Title: Advisory Committee on Reactor
Safeguards US EPR DCD Subcommittee
Meeting

Location: Rockville, Maryland

Date: Tuesday, April 6, 2010

Chapter 11, Radioactive Waste Management: Chapter Topics

► Evaporator - vapor-compressor with forced recirculation

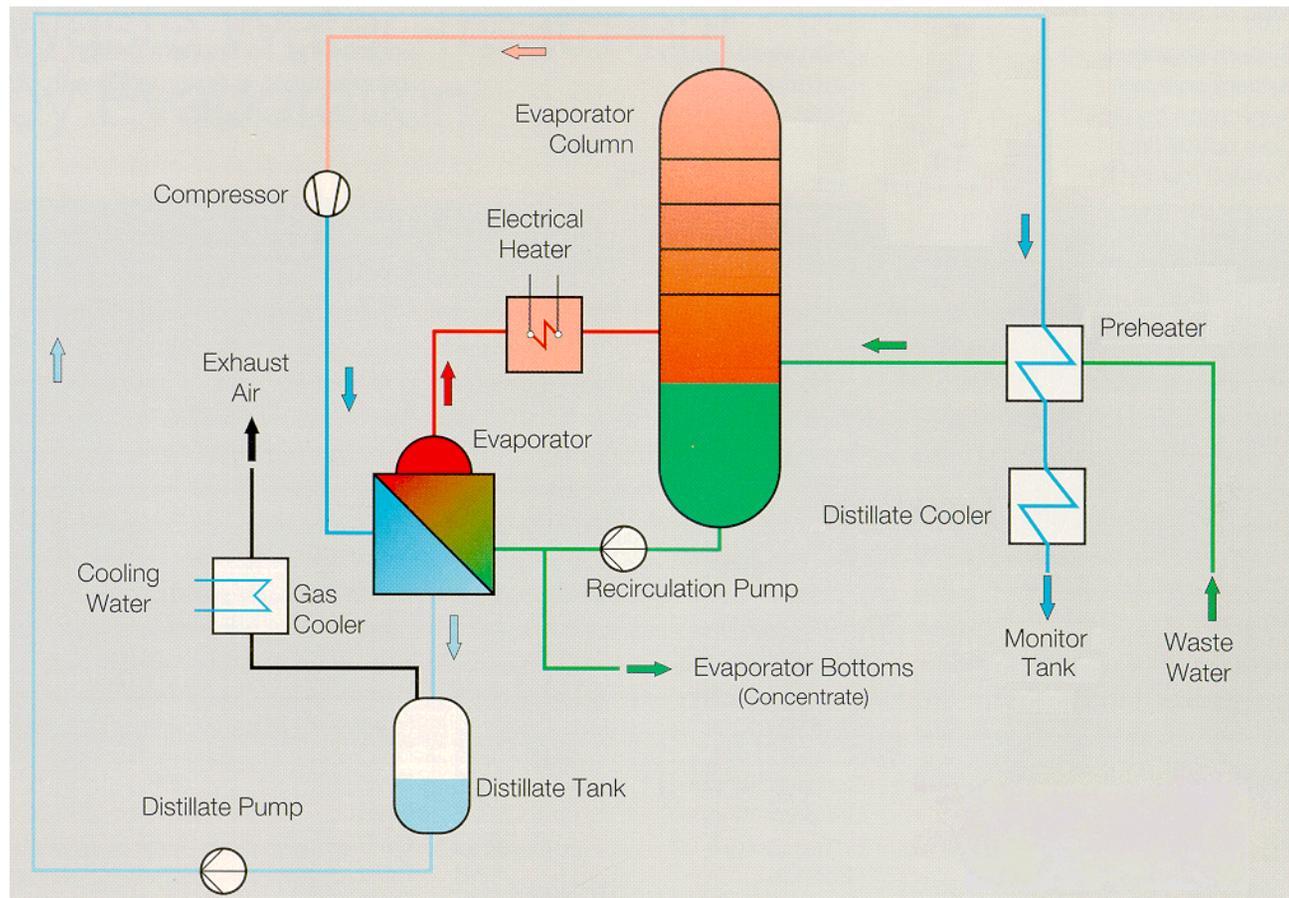
18 MEMBER BANERJEE: The only thing about
19 this that I would comment is that you've got a vapor
20 compressor which is a complicated piece of equipment,
21 and heat recovery in this system is quite a trick. So
22 I'm just wondering what drives you to these systems
23 rather than things like reverse osmosis, which are in
24 some ways much more straightforward.

► Centrifuge

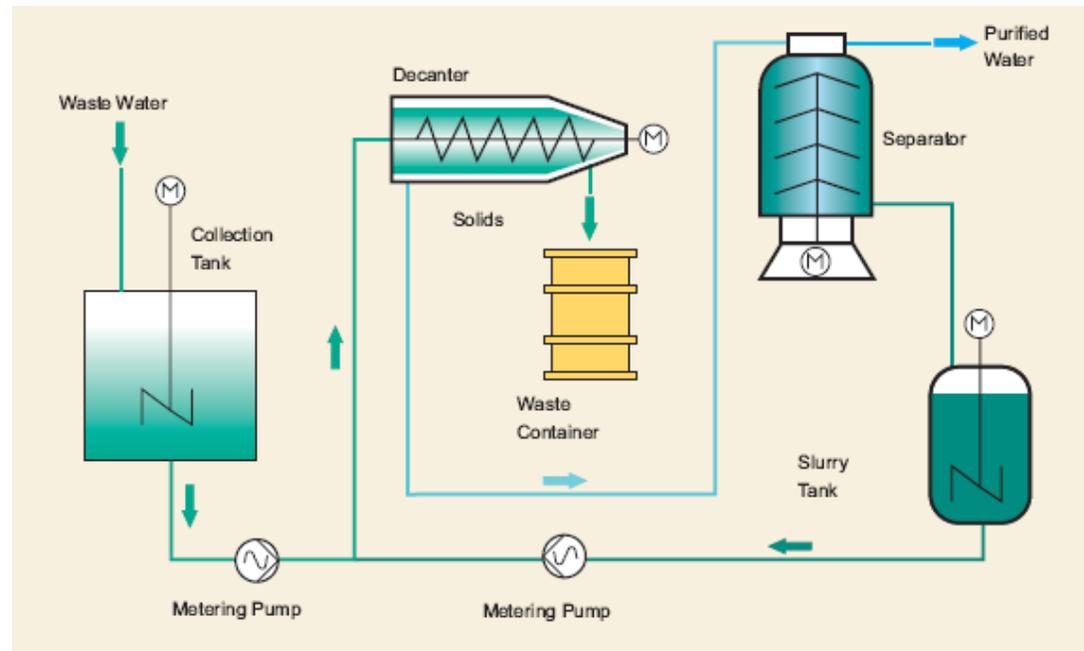
9 MEMBER STETKAR: Same question applies
10 for them, because the centrifuge is typically a fairly
11 high maintenance item. And here you start overloading
12 the evaporator.
